# Access Compliance Report

## Public Rights-of-Way

### (Pedestrian Signals)

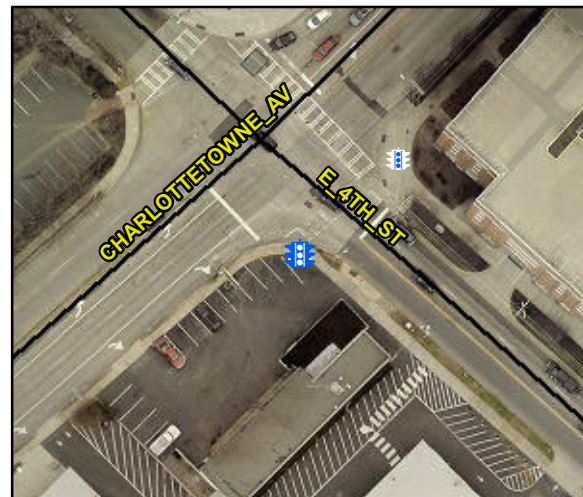
Intersection ID: N/A	Main Street:	Cross Street: N/A	Location: N/A
ADA ID: F982A2CB28A6	Signal Type: One Push Button-Non APS	Overall Compliance: No	Severity Score: BTN 1: N/A BTN 2: N/A No BTN: N/A
Codes/Mitigation Info/Possible Solution		Field Measurements/Component Compliance

Compliance	Description	Data	Compliance	Description	Data
	Button Count	Button1	N/A	Distant to Additional Button (in)	N/A
	Additional Button Present?	No		Additional Button ID	N/A
N/A	Signal Buttons Required?	N/A	N/A	Additional Ped Posts Required	N/A
	How Many Ped Street Xings?	1		Located In An Island/Median?	No
N/A	B 1 Sign Present?	Yes	N/A	B 2 Sign Present?	N/A
Yes	B 1 Sign Purpose?	Yes	N/A	B 2 Sign Purpose?	N/A
Yes	B 1 Sign Lettering & Contrast?	Yes	N/A	B 2 Sign Lettering & Contrast?	N/A
Yes	B 1 Parallel To XWalk?	Yes	N/A	B 2 Parallel To XWalk?	N/A
Yes	B 1 PAR to Button?	Yes	N/A	B 2 PAR to Button?	N/A
Yes	B 1 PAR to XWalk?	Yes	N/A	B 2 PAR to XWalk?	N/A
Yes	B 1 Clear Floor Space?	Yes	N/A	B 2 Clear Floor Space?	N/A
N/A	B 1 FWD Approach?	Yes	N/A	B 2 FWD Approach?	N/A
N/A	B 1 FWD Approach Constrained?	No	N/A	B 2 FWD Approach Constrained?	N/A
No	B 1 FWD Approach Reach (in)	9.0	N/A	B 2 FWD Approach Reach (in)	N/A

N/A	B 1 FWD Approach Width (in)	N/A	N/A	B 2 FWD Approach Width (in)	N/A
N/A	B 1 FWD Approach Obstruction?	Yes	N/A	B 2 FWD Approach Obstruction?	N/A
N/A	B 1 FWD Approach Obstruction Dist (in)	5.0	N/A	B 2 FWD Approach ObstructionDist (in)	N/A
N/A	B 1 PARA Approach?	Yes	N/A	B 2 PARA Approach?	N/A
N/A	B 1 PARA Approach Constrained?	No	N/A	B 2 PARA Approach Constrained?	N/A
Yes	B 1 PARA Approach Reach (in)	6.0	N/A	B 2 PARA Approach Reach (in)	N/A
N/A	B 1 PARA Approach Width (in)	N/A	N/A	B 2 PARA Approach Width (in)	N/A
N/A	B 1 PARA Approach Obstruction?	Yes	N/A	B 2 PARA Approach Obstruction?	N/A
N/A	B 1 PARA Approach Obstruction Dist (in)	3.0	N/A	B 2 PARA Approach ObstructionDist (in)	N/A
No	B 1 Clear Floor Space Slope (%)	5.6	N/A	B 2 Clear Floor Space Slope (%)	N/A
No	B 1 Clear Floor Space XSlope (%)	4.9	N/A	B 2 Clear Floor Space XSlope (%)	N/A
N/A	B 1 PAR Slope (%)	0.9	N/A	B 2 PAR Slope (%)	N/A
Yes	B 1 Height (in)	41.0	N/A	B 2 Height (in)	N/A

Possible Solutions: Provide Push Button Extension. Remove and Replace Clear Space.
